DINING OUT NYC

COMMUNITY BOARD RECOMMENDATION FORM

Business Name: Salinas

Application Number: 20240801010078

SECTION 1: Site Plan

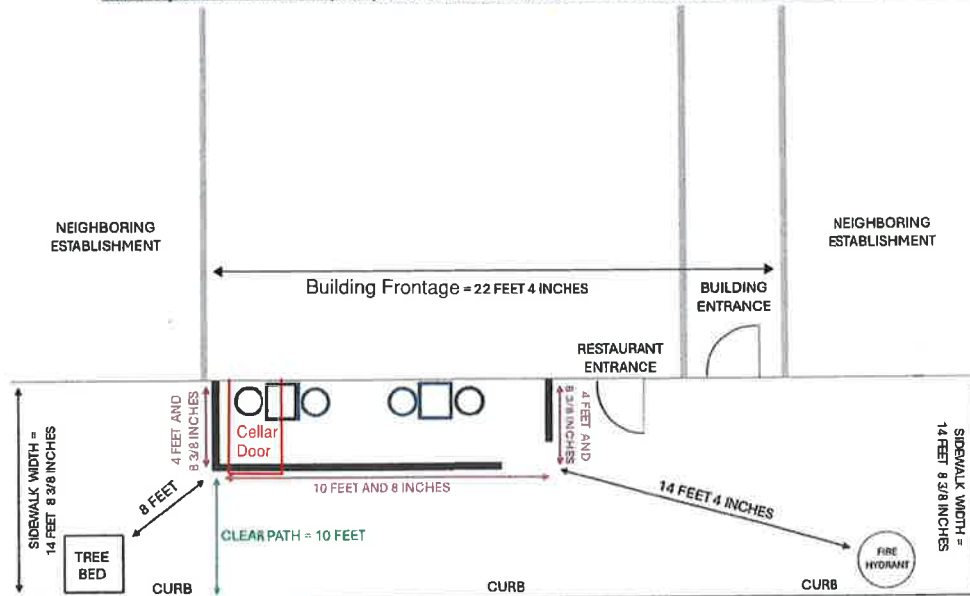
The proposed Site Plan does not provide for the required 10 foot pedestrian clear path on the north end of the sidewalk cafe (left side of the Site Plan) between the tree bed and the cafe perimeter.

To provide for the required 10 foot pedestrian clear path, MCB4 requests that the north table nearest the tree pit be moved to the south if space allows or, if there is insufficient space, that the north table with two chairs be removed. Applicant did not attend the meeting of MCB4's Business Licenses and Permits Committee at which this application was discussed and thus has not opined on this requested modification.
